31 October 2020

KUDUSBERG WEF ENVIRONMENTAL AUTHORISATION AMENDMENT: SPECIALIST IMPACT STATEMENT

Figure 4: The area of deviation of the Wind Collector System and 4x4 tracks that is proposed for a walkdown to identify any areas of archaeological sensitivity (RSA, 2020).

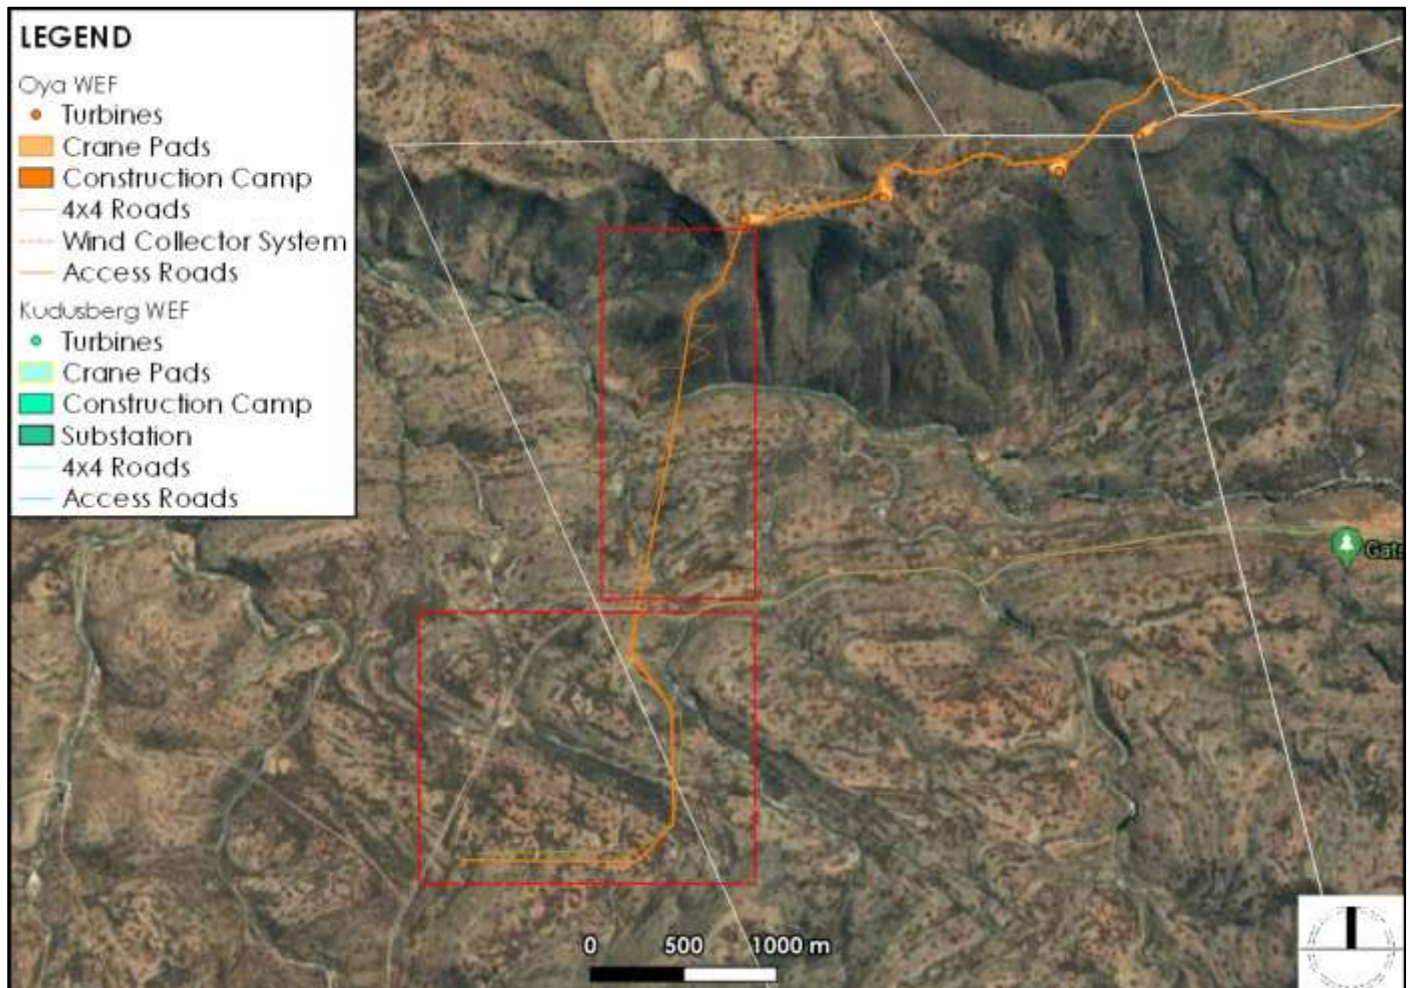
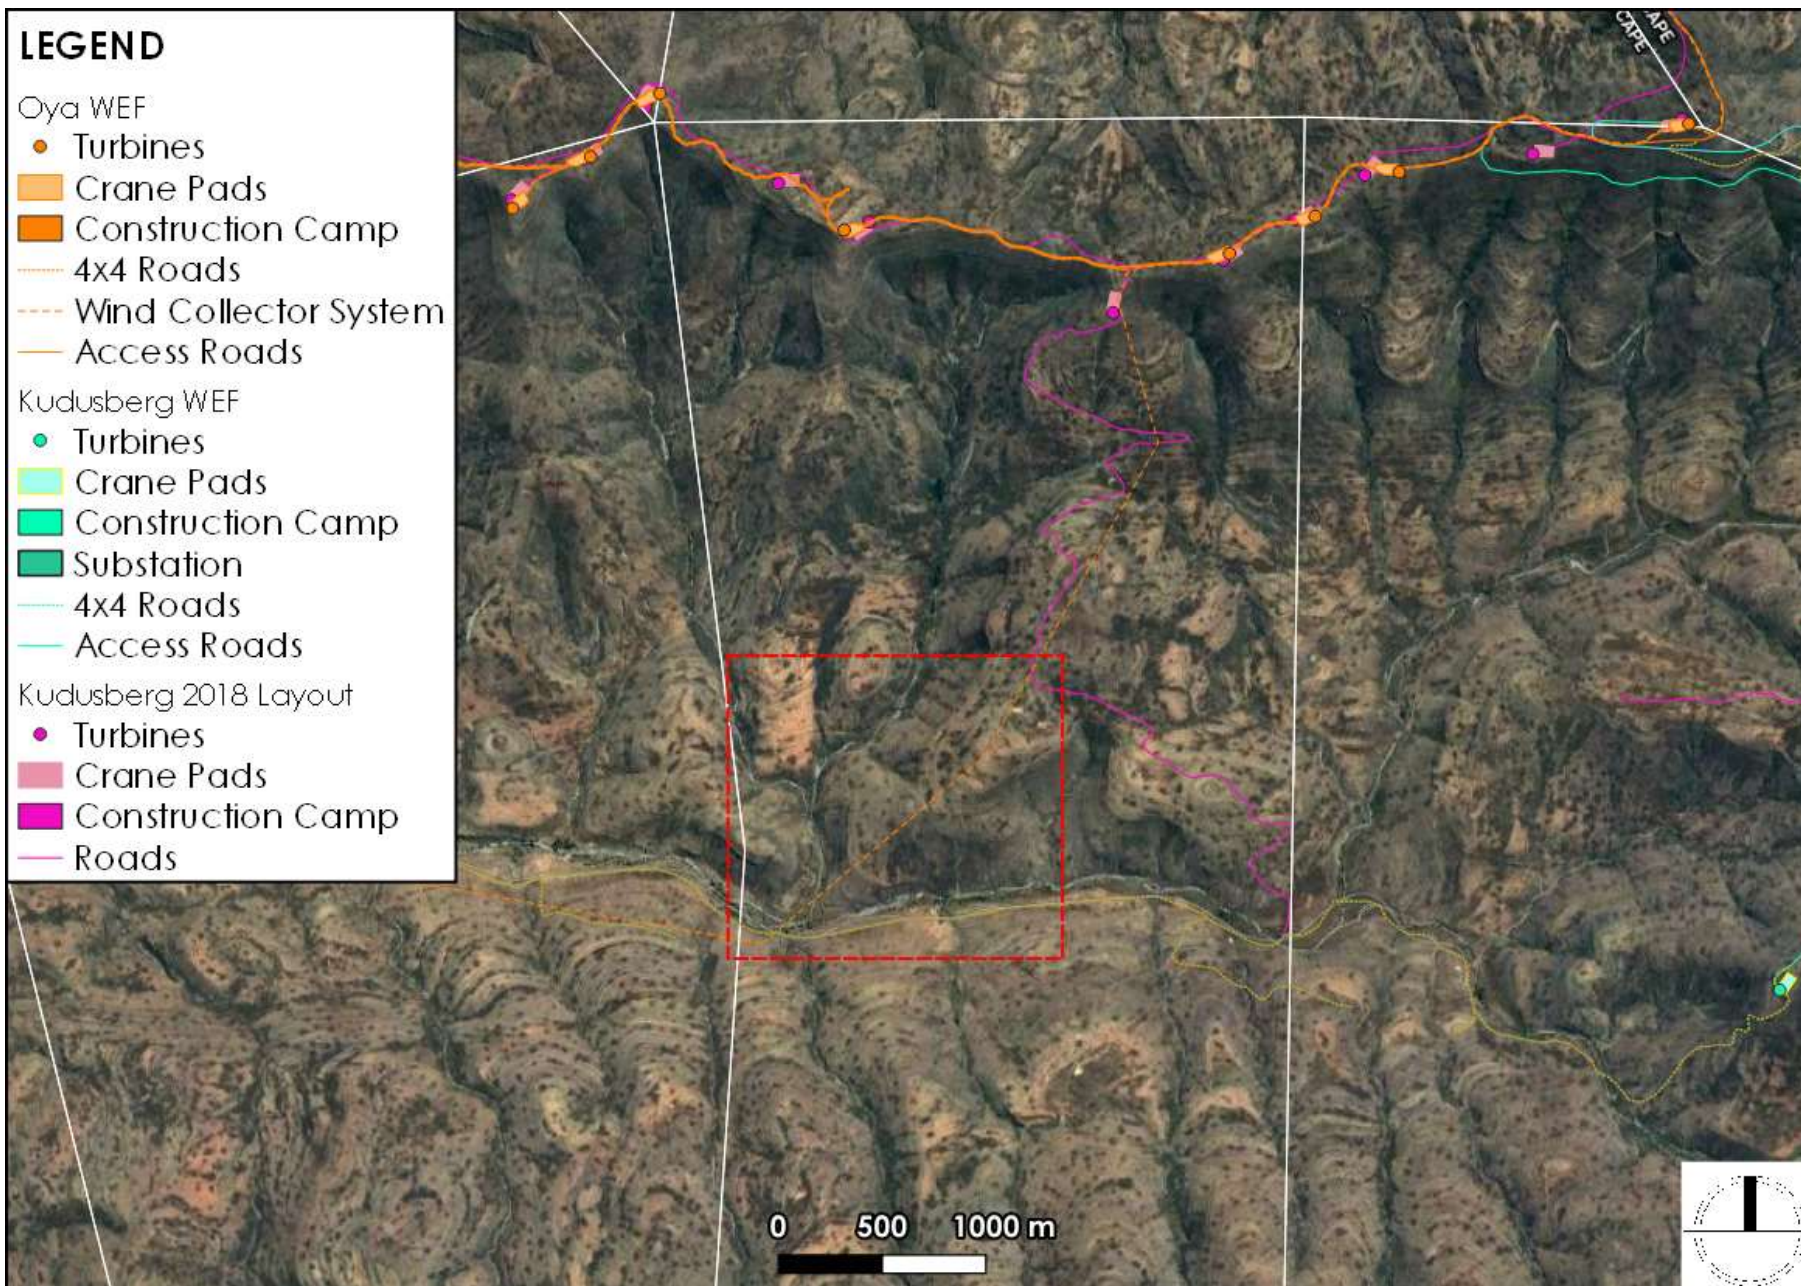
walkdown should be undertaken by a suitably experienced archaeologist as this new alignment could pose impacts to archaeological sites or features located there (see Figure 4 below). It should be noted that a detailed walkdown of the proposed layout is being undertaken by a suitably experienced archaeologist accordingly, and the findings are presented in a separate standalone walkdown report which does not form part of this letter.

Figure 5: The area of deviation of the Wind Collector System that is proposed for a walkdown to identify any areas of archaeological sensitivity (RSA, 2020).

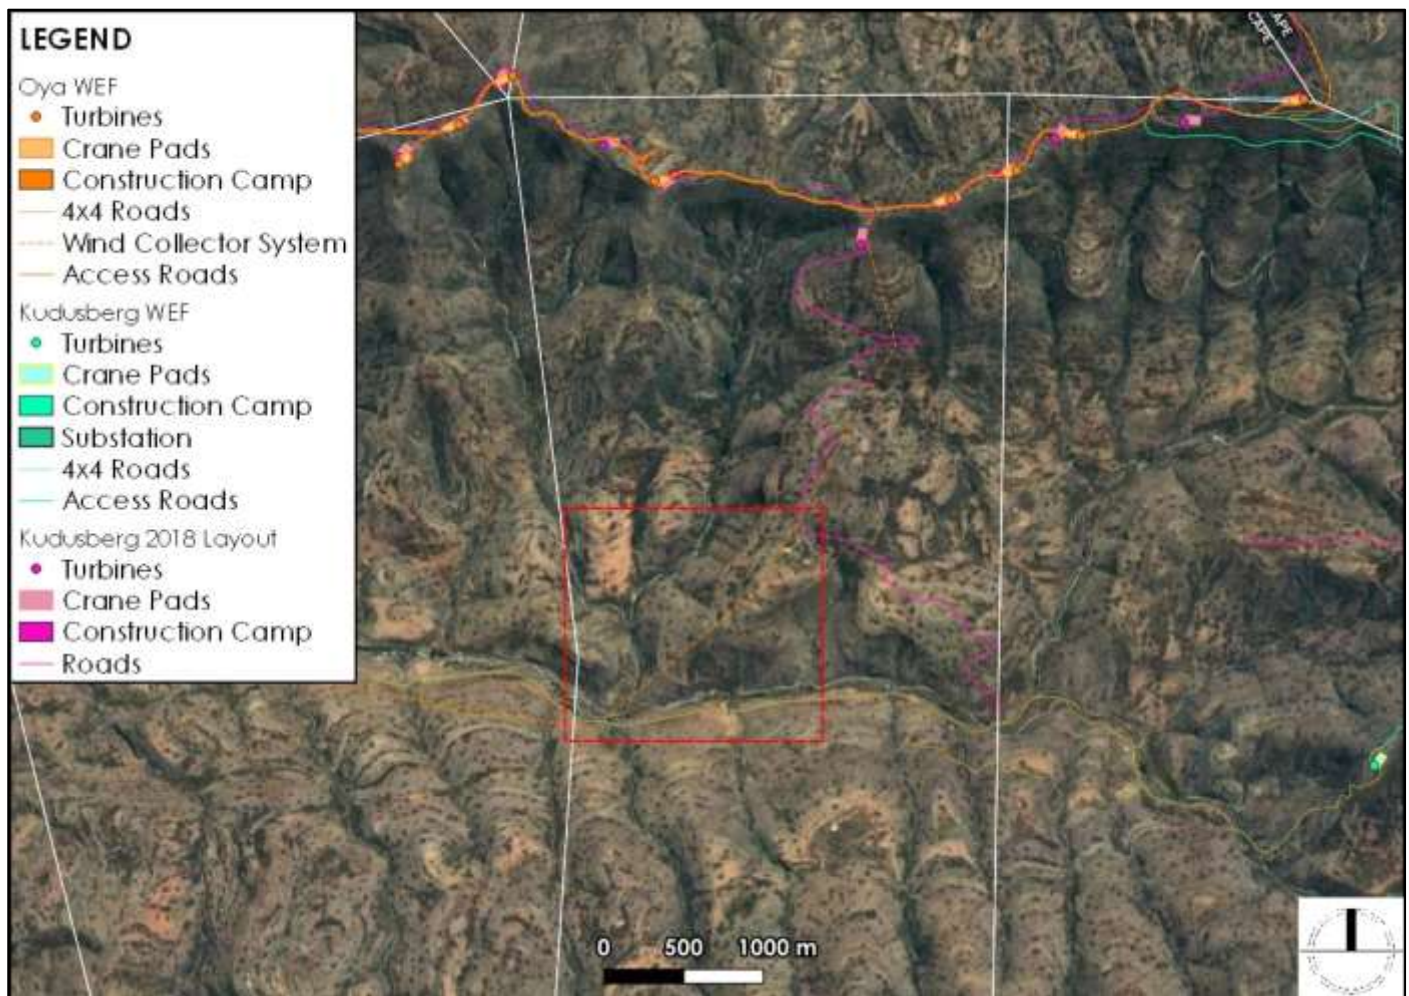
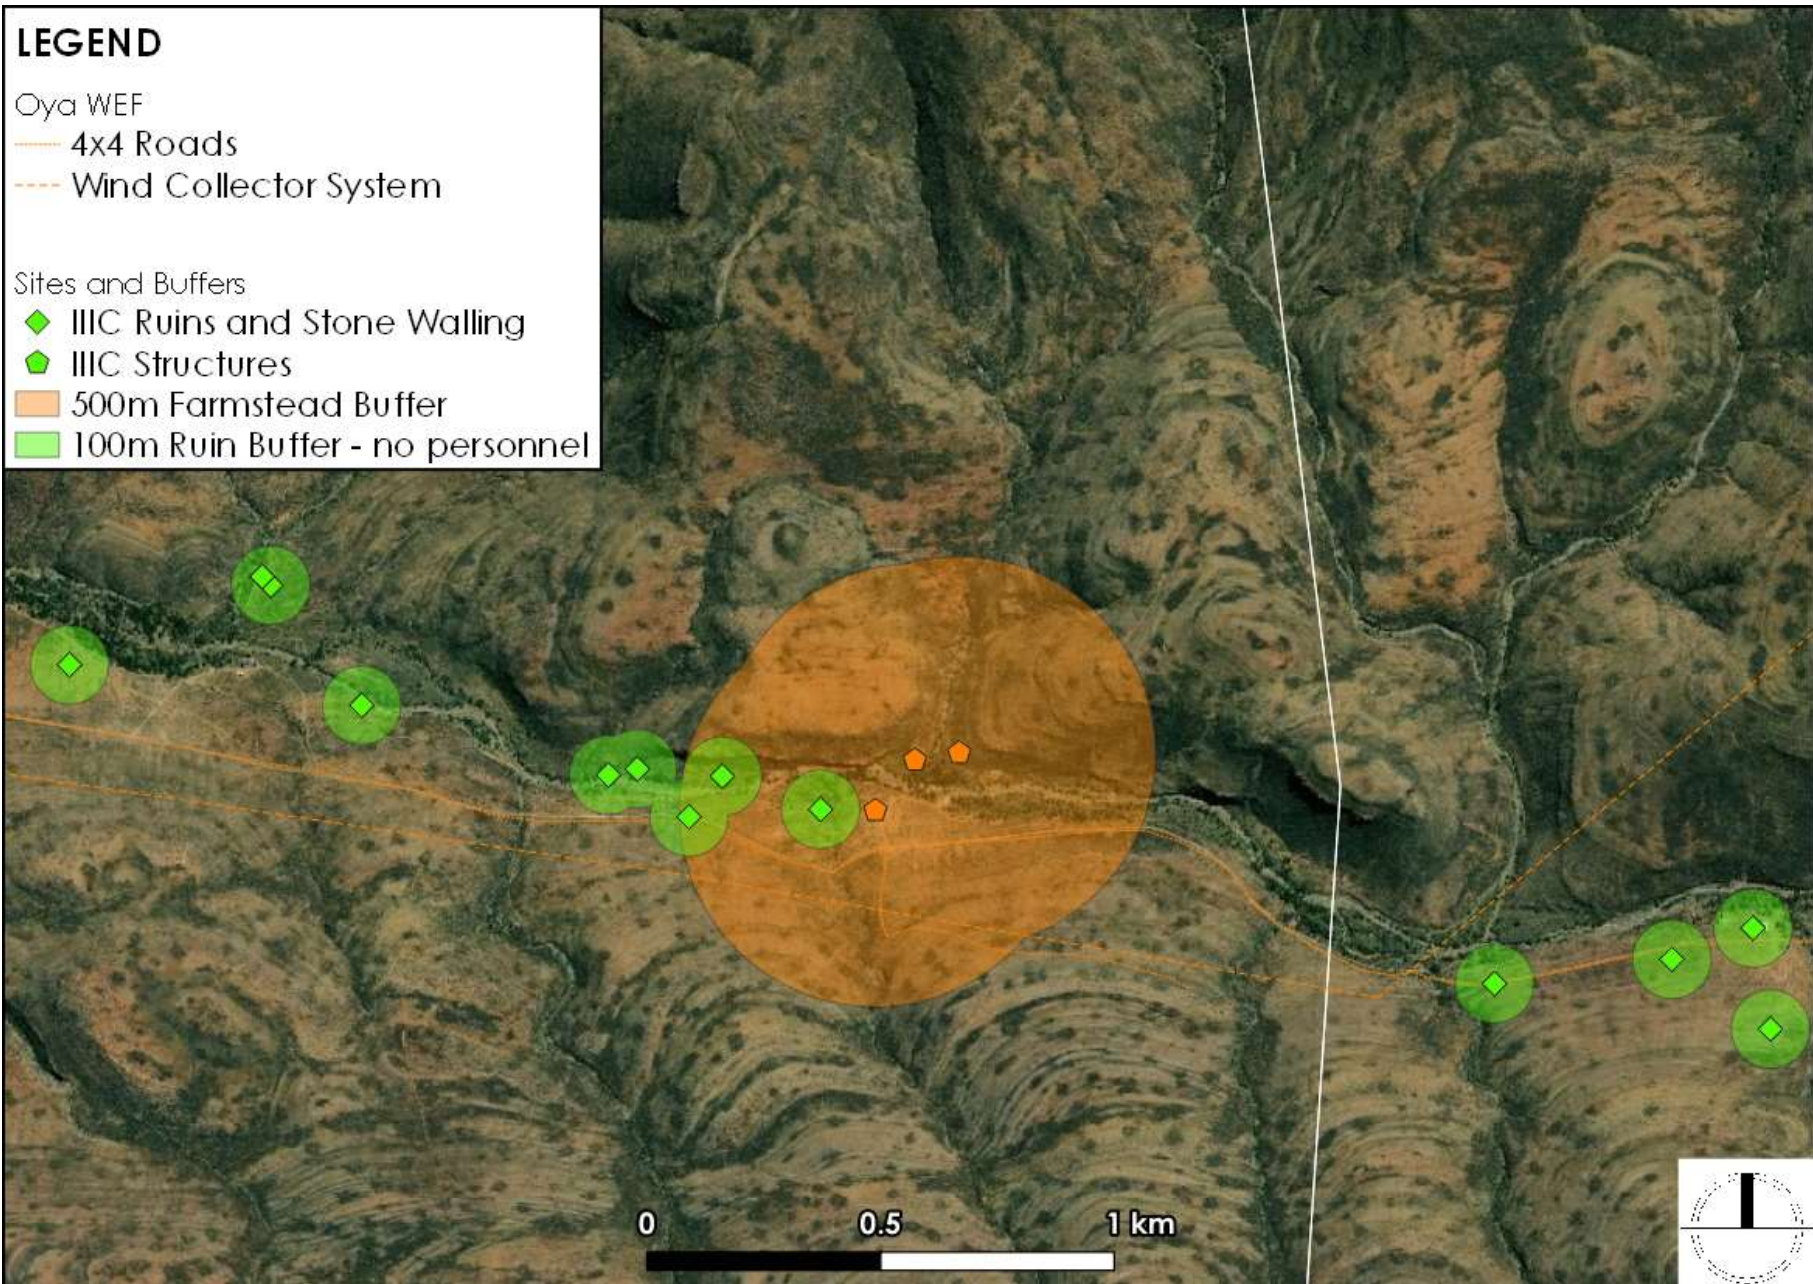
A further Wind Collector System is proposed along a route previously earmarked as an access road linking the central part of the Gatsrivier ridge to the valley floor. Where this new infrastructure follows the previously proposed access route, no new impacts are likely. However, where this route deviates from the previously proposed alignment, along the lower slopes of the mountain, this route should be subject to a walkdown by a suitably experienced archaeologist (see Figure 5 below).

Figure 6: Detail of known sites along Gats Rivier valley bottom, showing relative location of sites and buffers. The 500m farmstead exclusion zone applies only to turbine placement (RSA, 2020).

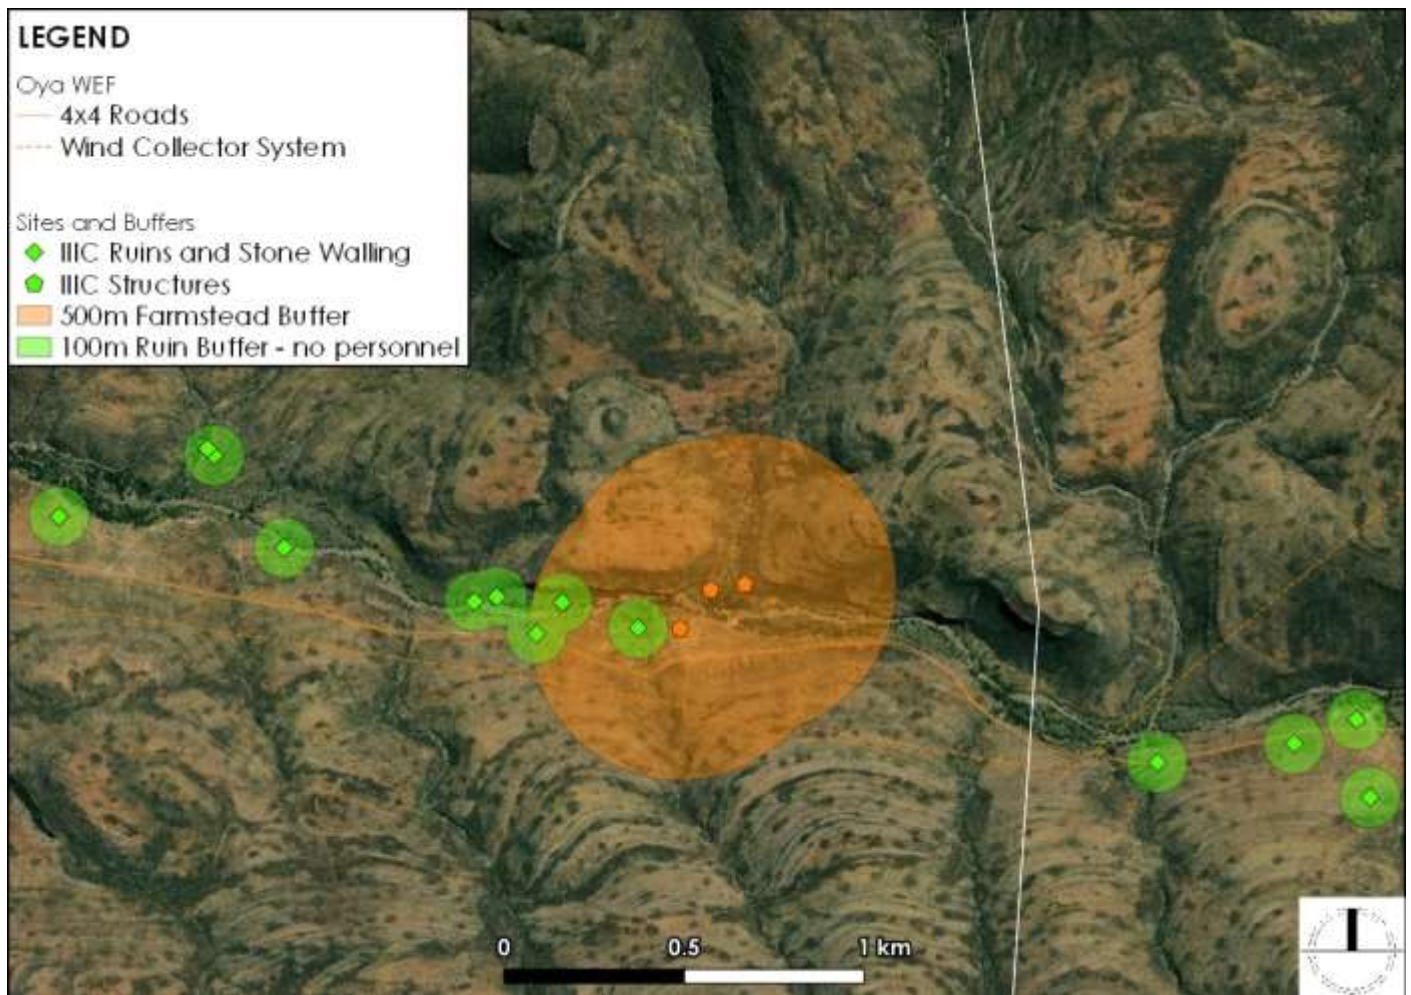
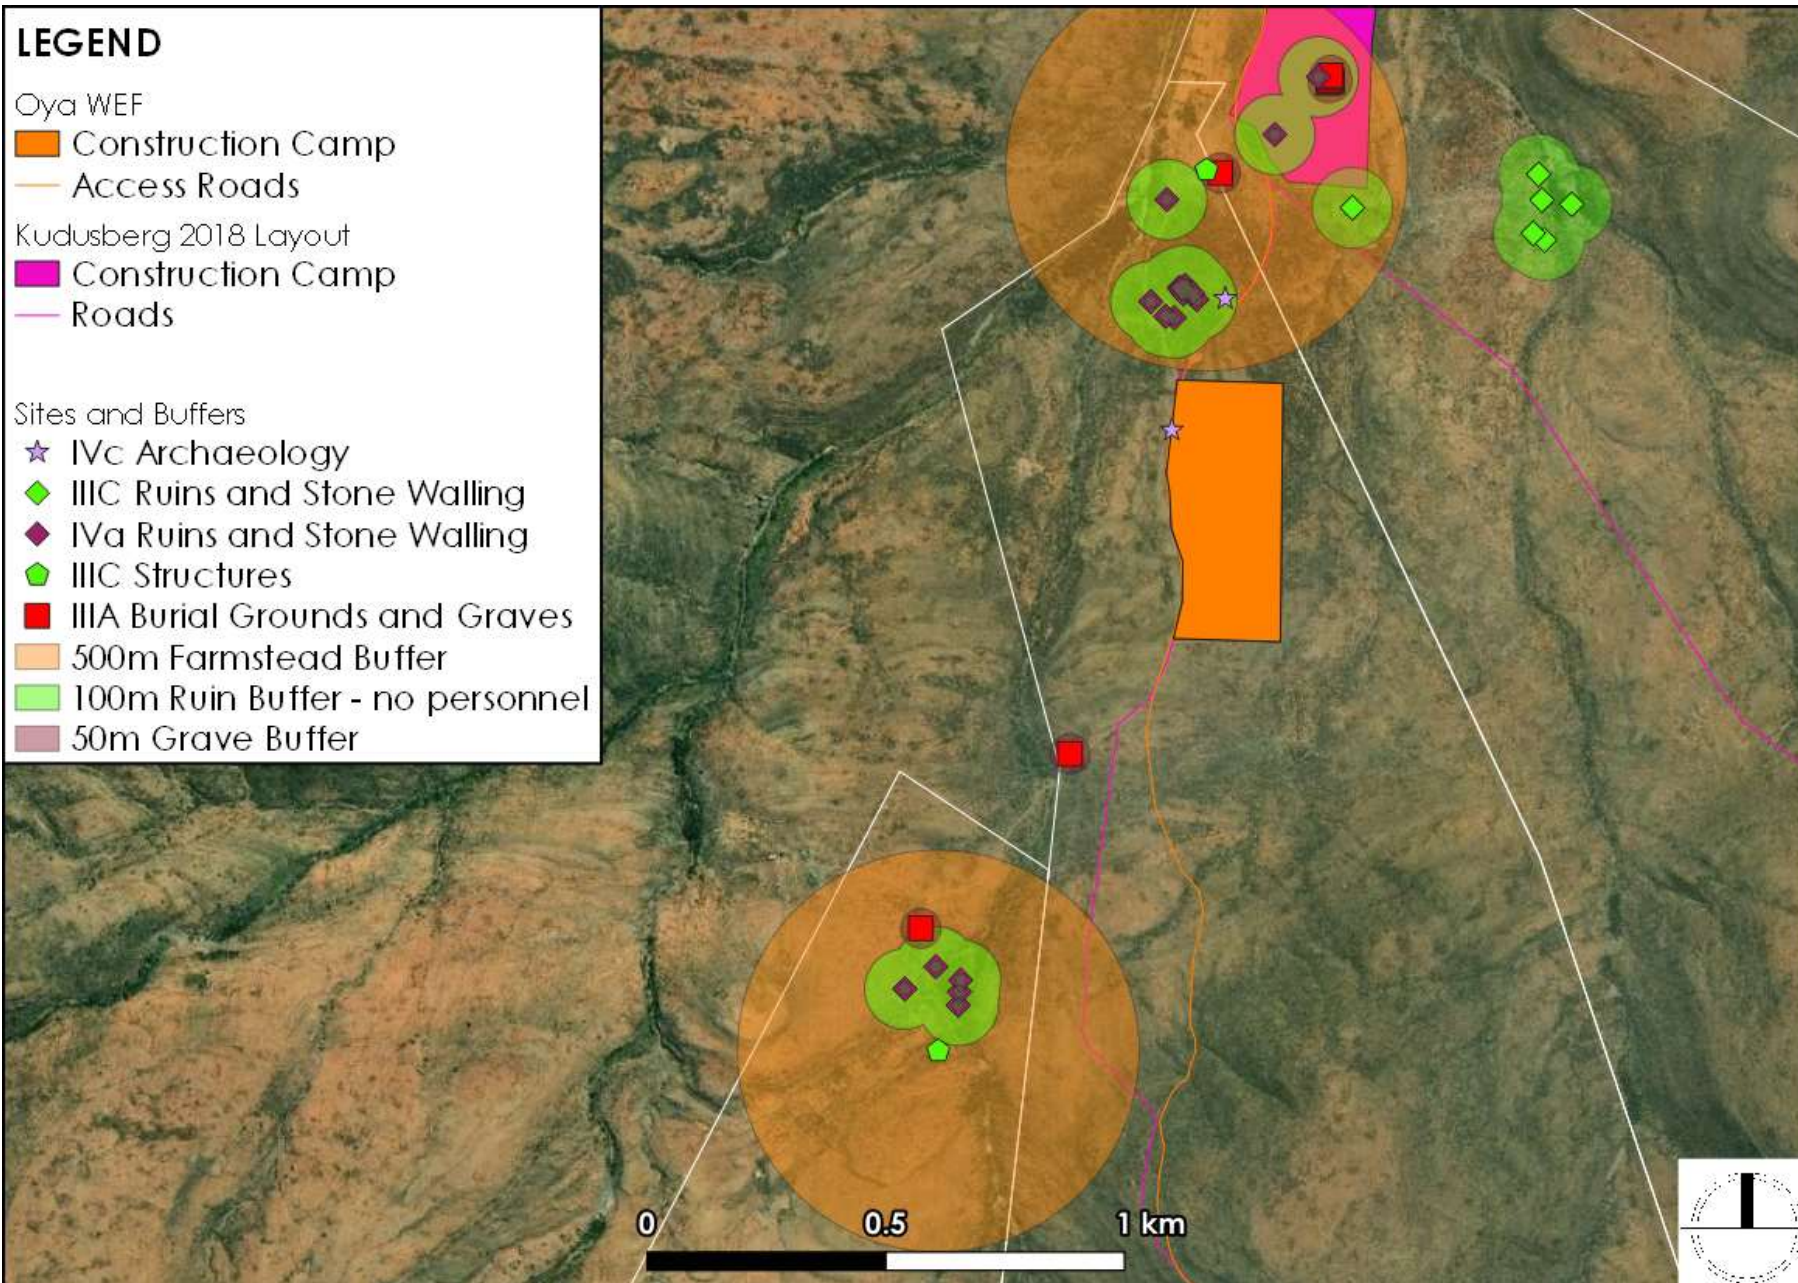
Due to the fact that the recommended walkdowns are being undertaken (part of separate standalone report), and appropriate mitigatory measures pertaining to heritage resources identified during the assessments have been recommended and provided in the EMP for implementation accordingly, it is not anticipated that the proposed changes will result in any further, different or greater impacts to heritage resources than those already identified in the 2018 HIA. All buffers previously imposed are respected and, in the case of the northern site clusters on Urias Gat, the new proposal increases the buffer between sites and infrastructure; no turbines are proposed for this area and these buffers pertain to road and construction infrastructure (Figure 6 and Figure 7 below).
